Access Compliance Report

Public Rights-of-Way

Intersection ID: 50635	Main Street: RED_WATER_RD	Cross Street: BLUE_BLOSSOM_RD	Location:	N
ADA ID: EAD04C5F1267	Ramp Type: Perp	Initial Pass/Fail: Fail	Overall Compliance: No	Severity Score: 10

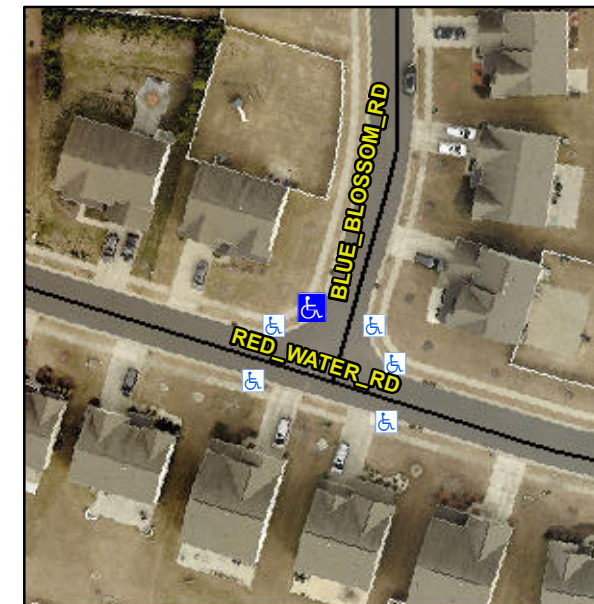
Not Found, R304.5.1, R304.5.3

Compliance	Description	Data	Compliance	Description	Data
N/A	Ramp Length (in)	47.0	Yes	Ramp Slope (%)	5.7
No	Ramp Width (in)	47.0	No	Ramp XSlope (%)	3.0
N/A	Flare Type LT	N/A	N/A	Flare Type RT	N/A
N/A	Flare Slope LT (%)	N/A	N/A	Flare Slope RT (%)	N/A
N/A	Flare Traversable LT?	N/A	N/A	Flare Traversable RT?	N/A
N/A	Landing Length (in)	N/A	N/A	DWS Provided?	N/A
N/A	Landing Width (in)	N/A	N/A	DWS Contrast?	N/A
N/A	Landing Slope (%)	N/A	N/A	DWS Length (in)	N/A
N/A	Landing X Slope (%)	N/A	N/A	DWS Full Width?	N/A
N/A	Landing Curb? (Y/N)	N/A	N/A	DWS Offset (in)	N/A
N/A	Shared Landing?	N/A			
N/A	Gutter Ponding?	N/A	N/A	Gutter Slope (%)	N/A
N/A	Gutter Lip Ht (in)	N/A	N/A	Gutter X Slope (%)	N/A
N/A	Painted X Walk1?	No	N/A	Painted X Walk2?	N/A
	X Walk 1 Direction	To SE		X Walk 2 Direction	N/A
N/A	X Walk 1 Width (in)	N/A	N/A	X Walk 2 Width (in)	N/A
	X Walk 1 Slope (%)	0.7		X Walk 2 Slope (%)	N/A
	X Walk 1 X Slope (%)	2.7		X Walk 2 X Slope (%)	N/A

Remove & Replace Entire Ramp.
